FCC Cover Letter

This letter is to inform you of our request for a Class 2 Permissive Change of our Device: FCC ID: CFS8DL5808W3AP to improve manufacturability. There has been no change in the Block diagram, however we have made the following changes to the schematic:

ORIGINAL SCHEMATIC:

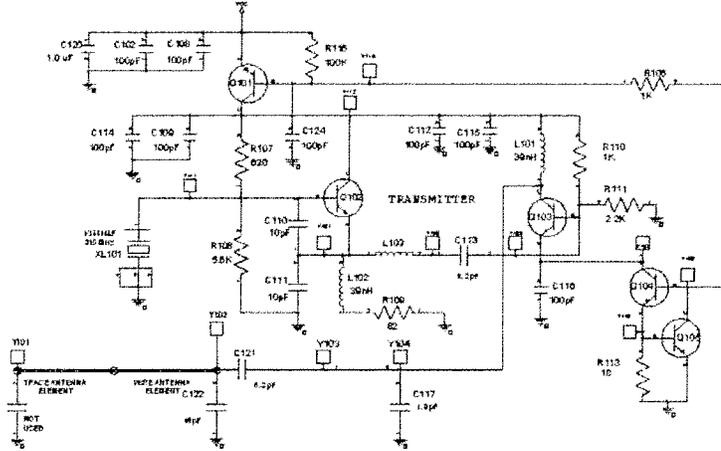
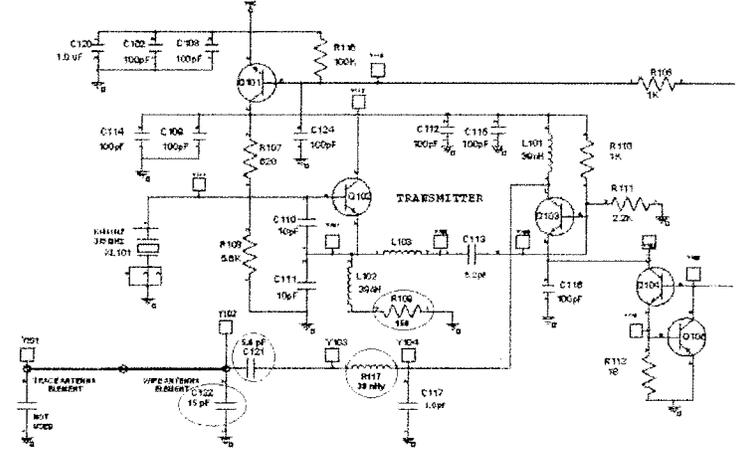
- R109 from 82 ohms to 150 ohms.
- R117 from 0 ohms to 39 nHy.
- C121 from 5.2 pF to 5.6 pF.
- C122 from 18 pF to 15 pF.

Emissions still meet FCC requirements and the changes are allowable under Part 15, Section 2.1043 of the FCC Rules. These changes will be only be made in those units produced after the Permissive Change is authorized. No confidentiality of submitted exhibits is requested.
